# The TRIUMPH Corporation

## SERVICE BULLETIN

68/1

SUBJECT: Fitting Lucas 2MC Capacitor to Triumph Motorcycles

# COMPETITION WIRING DIAGRAM WITH CAPACITOR FOR "B" & "C" RANGES

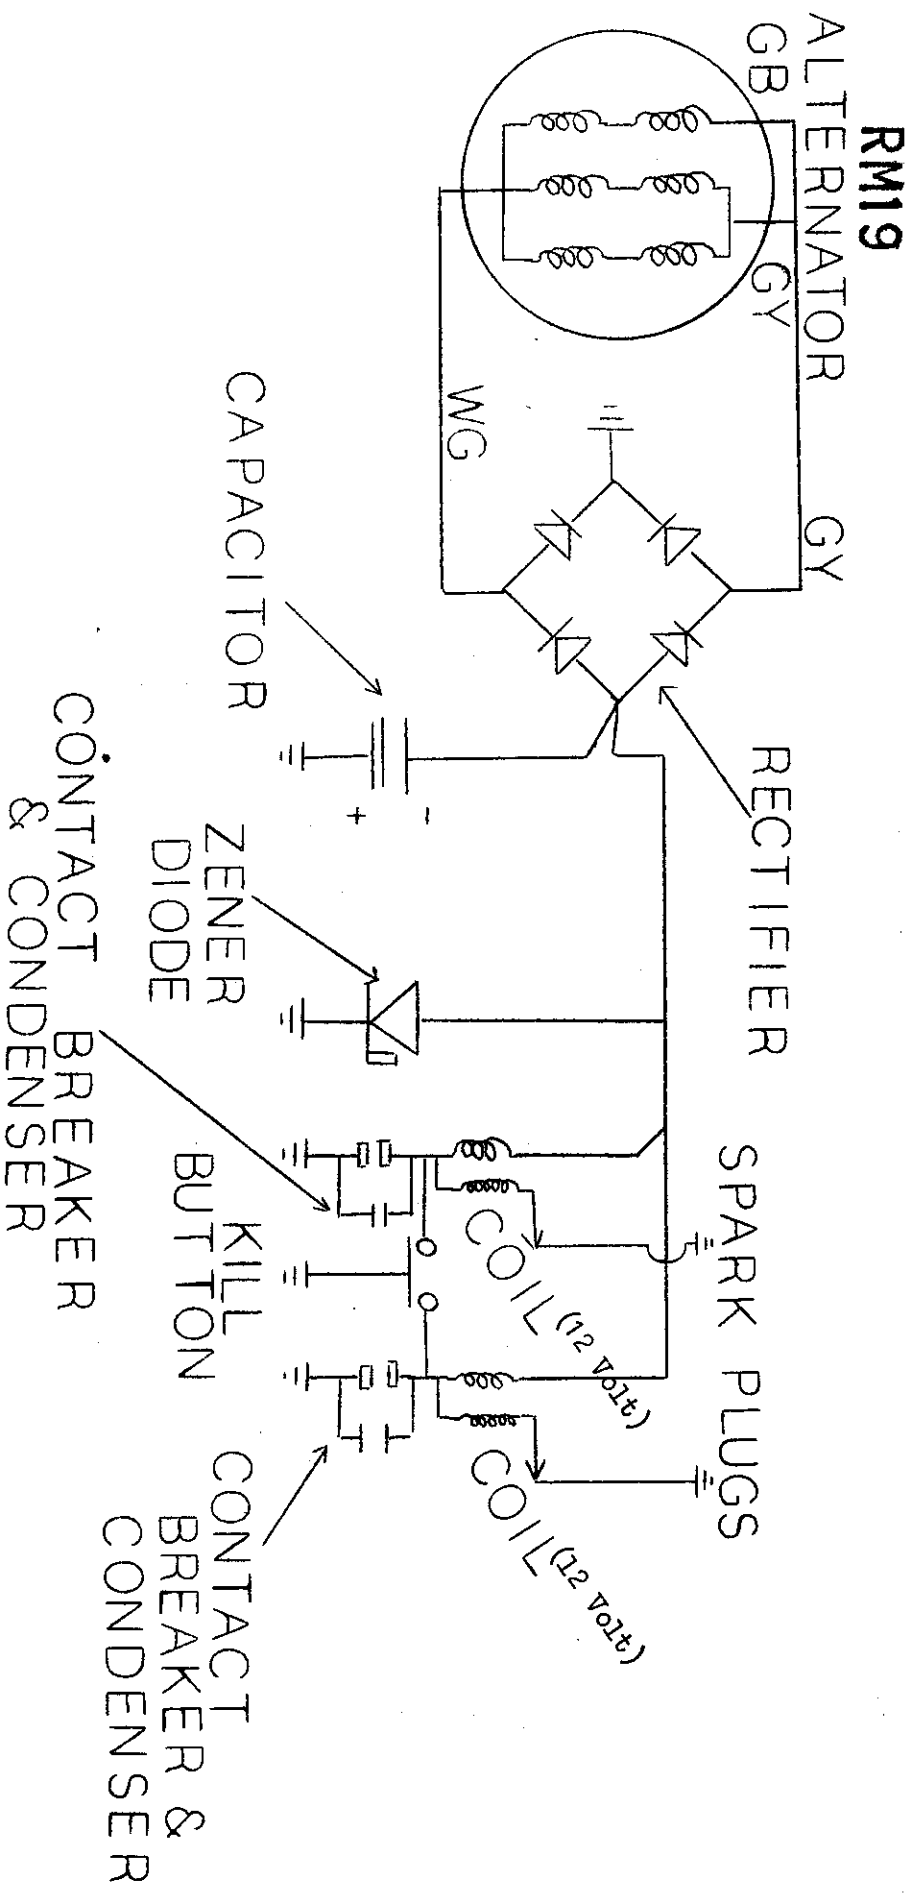
1. Lucas 2MC capacitor is only suitable for use on Zener diode regulated, alternator systems.
2. Front mounted, finned heat sink, No. H2237 should be employed.
3. The capacitor must be positioned with its terminals pointing downward.
4. Capacitor can be ruined if connected wrong. 3/16" Lucar terminal (red point dot) is positive. 1/4" Lucar terminal is negative.
5. Capacitor equipped Triumphs can be run with or without battery. If battery is removed, be certain to insulate negative battery wire from ground. Otherwise capacitor may be ruined.
6. If battery is removed, lights must be switched off to allow engine to be started. On the back of this page is a simplified wiring diagram which can be used for competition Triumphs where you require neither battery or lighting equipment.
